SOUTH DOWNS NATIONAL PARK AUTHORITY

SDNPA Consultation Response

Draft Response

1. The South Downs National Park Authority (SDNPA) notes that Highways England (HE) is consulting on a single option only for the M3 Junction 9 scheme. The proposal (option 14) is to provide free flowing road links between the M3 and the A34 both northbound and southbound. The new road connections will pass each other and the existing M3 via a combination of flyovers and underpasses. New embankments, cuttings and retaining walls will be required to achieve this.

Zone of theoretical visibility M3 Junction 9
Map I: Landform Effects

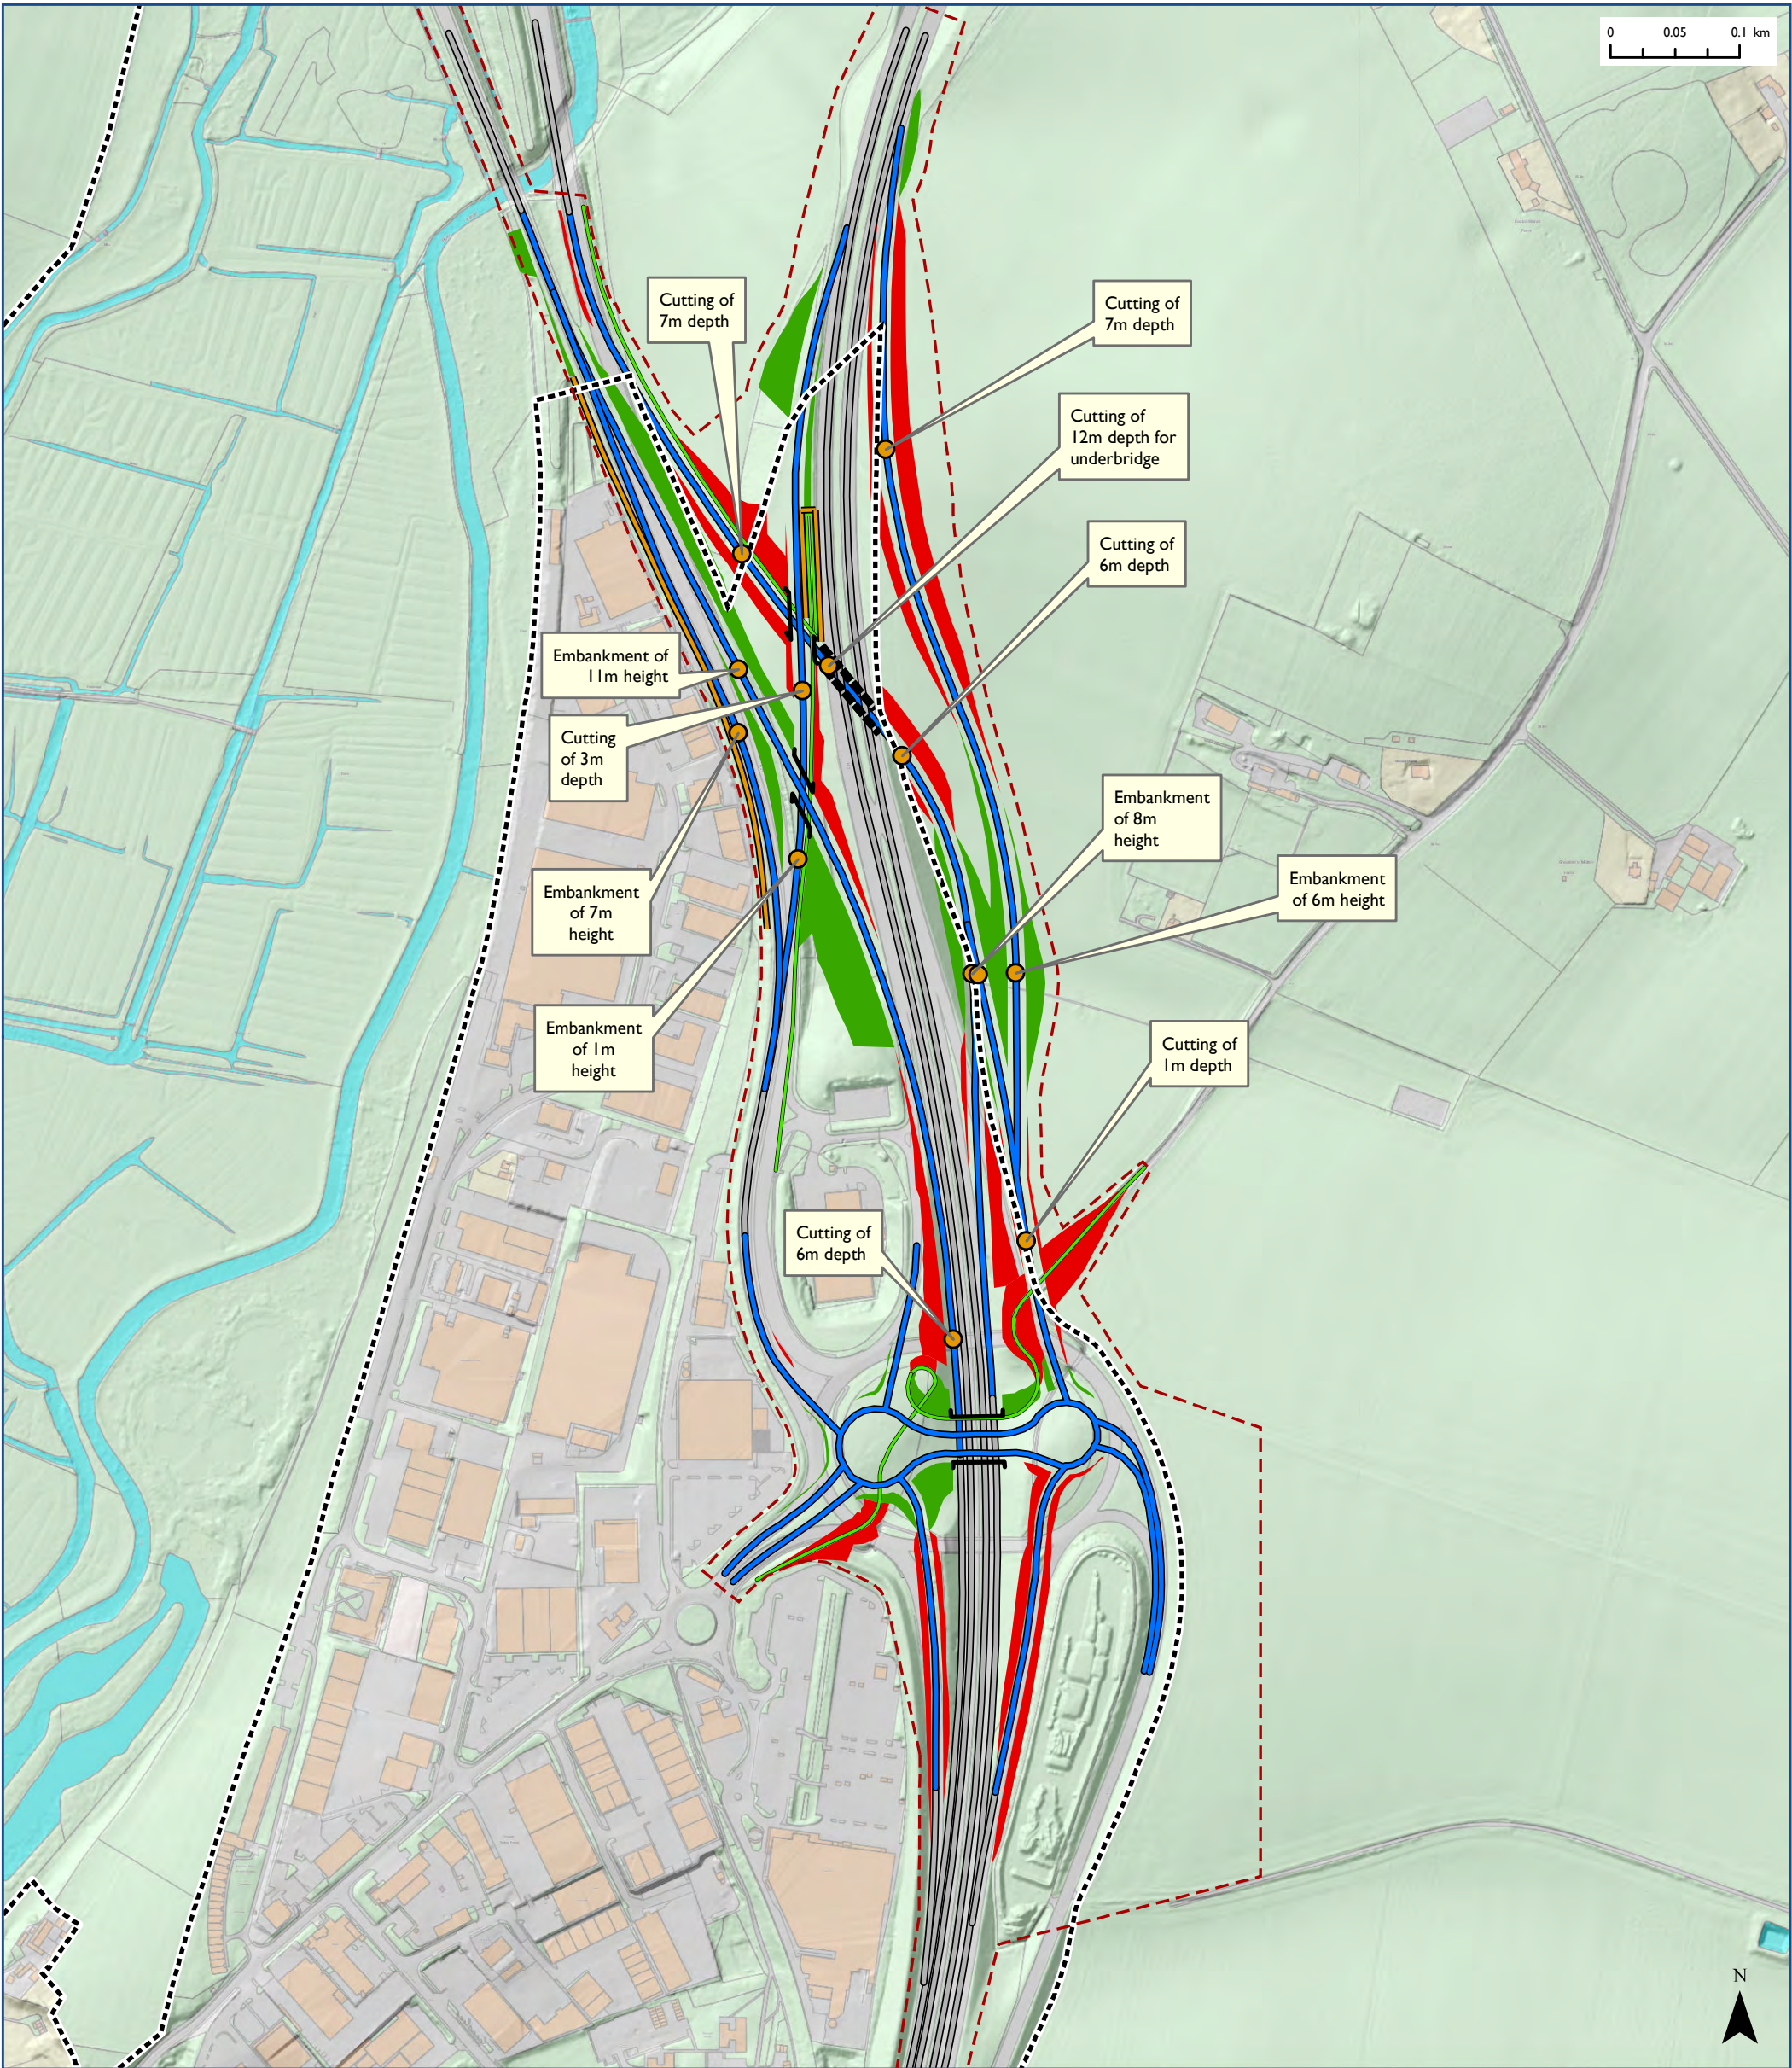
- This shows new straight through connections in all directions between the M3 and the A34/A33. 3 bridges would be required to facilitate this. The heights of embankments and cuttings which will be needed to accommodate the straight through connections are shown on Figure xvi Landform effects
